Access Compliance Report Public Rights-of-Way (Curb Ramps)

Main Street: HAZARD_AVE Cross Street: NEWLAND_ST Location: SE

ADA ID: RPAT220221150954 Ramp Type: Type 4 - Parallel Initial Pass/Fail: Fail Overall Compliance: No Severity Score: 16

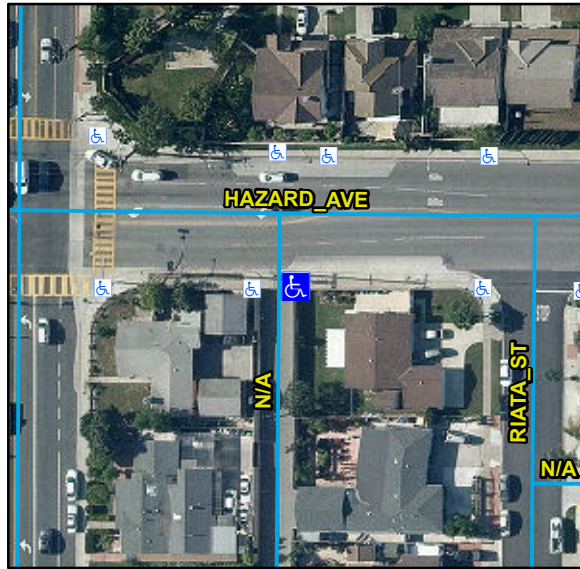
Compliance	Description	Data	Compliance	Description	Data
N/A	Ramp Length LT (in)	90	N/A	Ramp Length RT (in)	86
Yes	Ramp Width LT (in)	87	Yes	Ramp Width RT (in)	102
No	Ramp Run Slope LT (%)	9	Yes	Ramp Run Slope RT (%)	6.7
No	Ramp Cross Slope LT (%)	4.7	No	Ramp Cross Slope RT (%)	3.3
N/A	Landing Present	N/A	N/A	DWS Provided	N/A
N/A	Landing Length (in)	N/A	N/A	DWS Contrast	N/A
N/A	Landing Width (in)	N/A	N/A	DWS Length (in)	N/A
N/A	Landing Run Slope (%)	N/A	N/A	DWS Full Width	N/A
N/A	Landing Cross Slope (%)	N/A		DWS Offset Type	N/A
N/A	Landing Movement Obstructed?	N/A	N/A	DWS Offset Left (in)	N/A
	Landing Movement Type	N/A	N/A	DWS Offset Right (in)	N/A
N/A	Landing Shared	N/A			
N/A	Clear Space	N/A			
N/A	Clear Space To Crosswalk (in)	N/A			
N/A	Marked Crosswalk 1	No	N/A	Marked Crosswalk 2	N/A
	Crossing 1 Direction	W		Crossing 2 Direction	N/A
	Marked Crosswalk 1 Width (in)	N/A		Marked Crosswalk 2 Width (in)	N/A

Remove & Replace Entire Ramp.

R304.3.2, R304.5.3, STD 1115
